## Linden Forest, Administrative Subdivision Plan No. 620200150

Request to create two lots from two parcels of land for two single-family detached houses.

## **PRELIMINARY PLAN RECOMMENDATION AND CONDITIONS**

Figure 3: Administrative Subdivision Plan

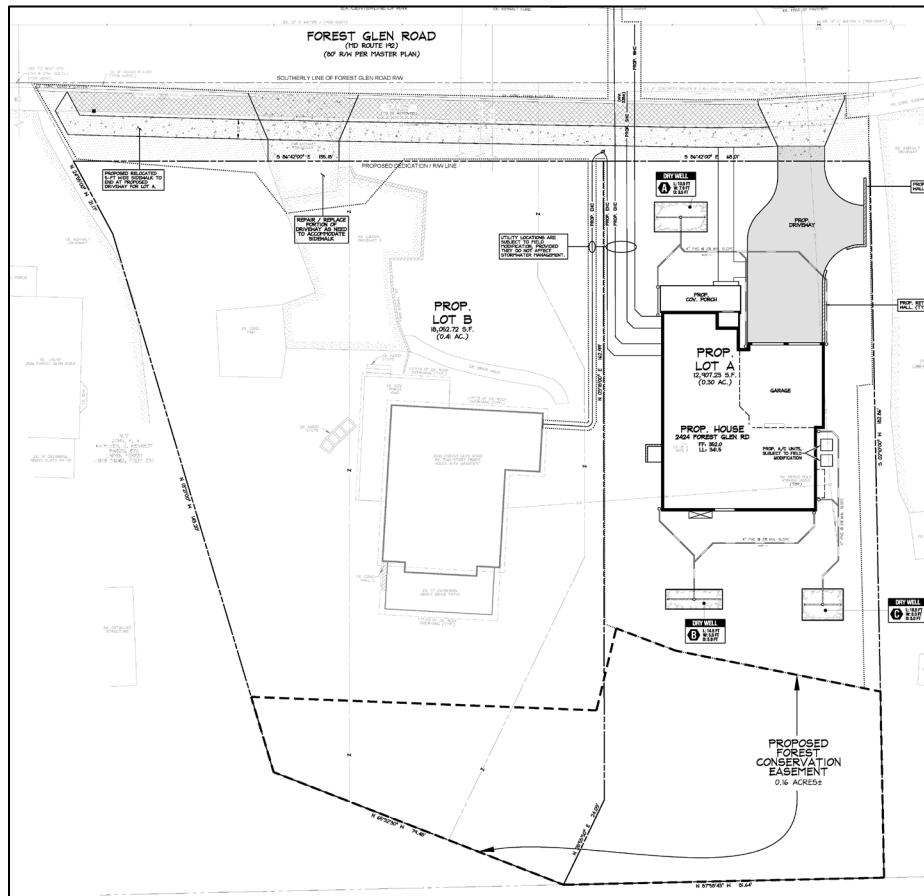
The proposed lots are providing the required road dedications and will be shown on the plat. The applicant is showing the required improvements to the frontage of the Property, and the Applicant is required to construct a five (5) foot sidewalk, separated from vehicular traffic by an eight (8) foot lawn panel. However, the Applicant is contesting the frontage improvements, which will be discussed in detail below.

Consistent with Vision Zero principles, Applicants are expected to implement pedestrian and/or master-planned bicycle facilities with at least eight (8) feet of separation between the cartway and the facility. This can be in the form of landscaping, tree panels, on-street parking, or other forms of hardened vertical separation. In this case, the Applicant is required to create an eight (8) foot landscaped buffer between the road and the sidewalk. The required improvement is shown in the submitted Plan, but the Applicant is looking for relief from the Planning Board of this requirement.

11. The Applicant must provide and show on the record plat:
  - a. Dedication of twenty (20) feet of right-of-way, for a total of forty (40) feet of right-of-way from the centerline on Forest Glen Road.
12. Prior to issuance of the building permit for a residential unit, the Applicant must improve the Forest Glen Road frontage with a five (5) foot sidewalk, separated from vehicular traffic by an eight (8) foot lawn panel.

**Figure 4: Final Forest Conservation Plan**

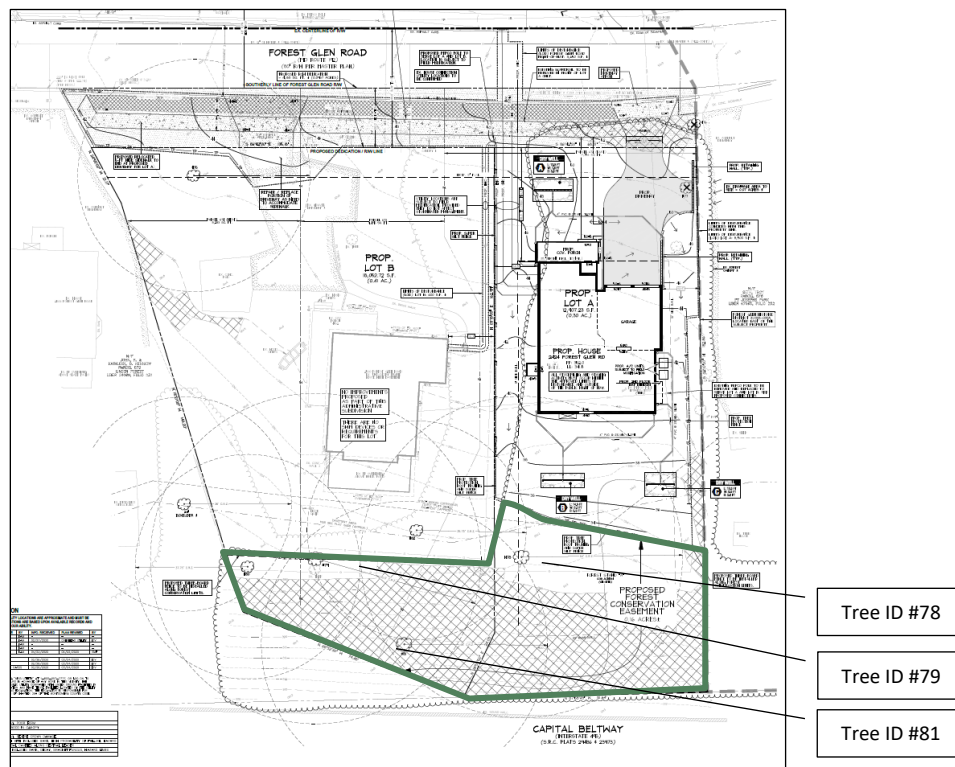
Additionally, the forest conservation plan shows that the Limit of Disturbance coincides with the eastern property line, which is shared with the abutting historic district. The certified plan will include a revision that shows the LOD at least 5-feet off the property line to avoid impacts on the existing tree line in this area.

- b. Revise the Forest Conservation Plan to remove all references to forest retention and Category I Conservation Easements.
15. The Applicant must include the stormwater management concept approval letter and Administrative Subdivision Plan Resolution on the approval or cover sheet(s).

Figure 6: 1996 *Forest Glen Sector Plan* Illustrative Section of Forest Glen Road

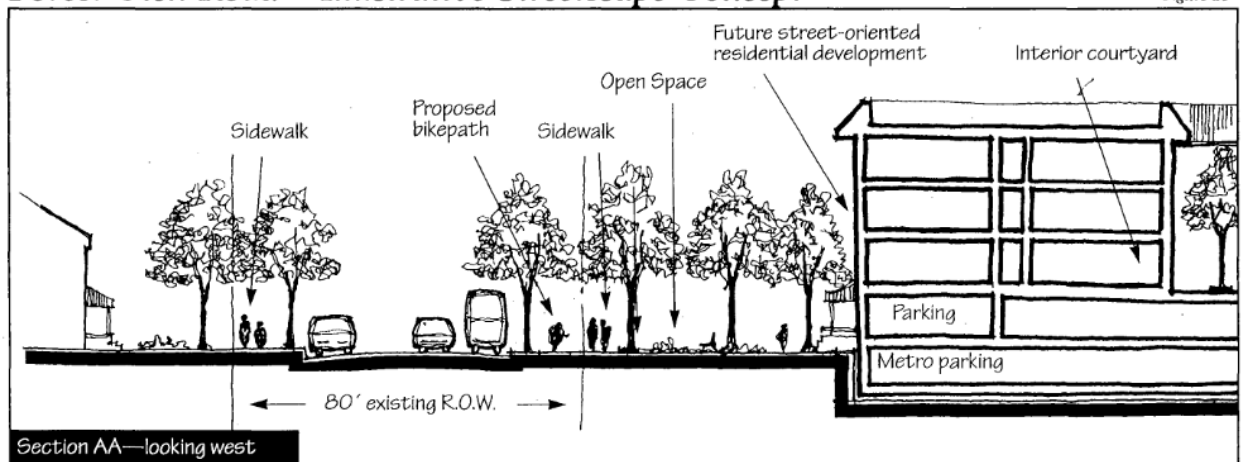
The 1996 *Forest Glen Sector Plan* recommends five (5) feet of separation between the sidewalk and curb on Forest Glen Road—one (1) foot less than the requested improvement—and depicts trees separating pedestrians from traffic at the location as shown in Figure 6.
